NIE Networks' Generator Interface Protection Amendment Project

Consultation Report and Next Steps

22/09/17

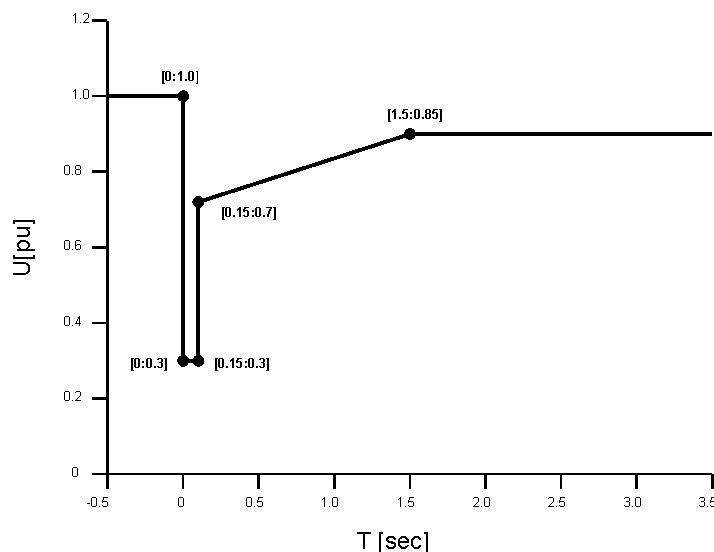
Nordex	<p><u>Consultee Comment:</u> The protection settings are indicating that a power station >5MW might be required to stay connected to the grid while the frequency is above 53 Hz for a short period. Starting at 51.9 Hz where still no protection will kick in, we might have a fast frequency movement with 1.499 Hz/s so RoCoF will also not trigger. When crossing the 52 Hz we have to stay connected for a further second, so it is possible to reach 53.499 Hz or higher values before given protection settings will disconnect the power station.</p> <p>Our default settings for protecting the turbines is 53 Hz with a delay of 0.2 s. Does that mean we would not be compliant? I know, I'm mentioning a very unlikely event, but it makes me uncertain how to implement the protection setting in a compliant way without having upper frequency values up to 54 Hz.</p> <p>Also it is not described that the 1.5 Hz/s RoCoF is a minimum requirement. So I suppose we wouldn't be allowed to implement higher gradients for df/dt protection than 1.5 Hz/s? But for grid stability I guess it would be in the favour of a network operator to have the generating units withstand higher gradients as these gradient are also relevant for a falling frequency. Suggestion would be:</p> <ul style="list-style-type: none"> - to define an upper limit for frequency were a unit is allowed/required to disconnect immediately like e.g. 53 Hz. - to define 1.5 Hz/s as a <u>minimum</u> requirement <p><u>NIE Networks' Response:</u> 1) Define an upper limit for frequency were a unit is allowed/required to disconnect immediately like e.g. 53 Hz.</p> <p>Clause 7.13.5 of the NIE Networks' Distribution Code states: Each Generator shall be responsible for protecting the Generating Unit owned or operated by it against the risk of damage which might result from any Frequency excursion outside the range 52 Hz to 47 Hz and for deciding whether or not to interrupt the connection between its Plant and/or Apparatus and the Distribution System in the event of such a Frequency excursion. Therefore, a generator may wish to disconnect from the distribution system, by interrupting the connection between its plant and/or apparatus, if frequency increases beyond 52Hz.</p> <p>2) Define 1.5 Hz/s as a <u>minimum</u> requirement.</p> <p>NIE Networks do not allow generators to implement an interface protection RoCoF setting which is higher than that stated in connection agreements or in the appropriate network code. Higher RoCoF settings will increase the risk of electrical islands being maintained and therefore increases the risk of electrocution and out-of-phase reclosure of generation. Consequently, NIE Networks will not define 1.5Hz/s as a minimum requirement.</p> <p>For the avoidance of doubt NIE Networks has removed paragraph 7.11.7 from the proposed D-Code modifications.</p>

~~7.11.7 Each **Generator** must ensure that, in relation to each of its **Power Stations**, any **Protection** installed to meet its own requirements does not interfere with the correct operation of the **Protection** requirements detailed in paragraph CC7.11. For the avoidance of doubt, any **Protection** employed by the **Generator** should not operate to disconnect the **Power Station** from the **System** ahead of the operation of the **Protection** as required in paragraph CC7.11~~
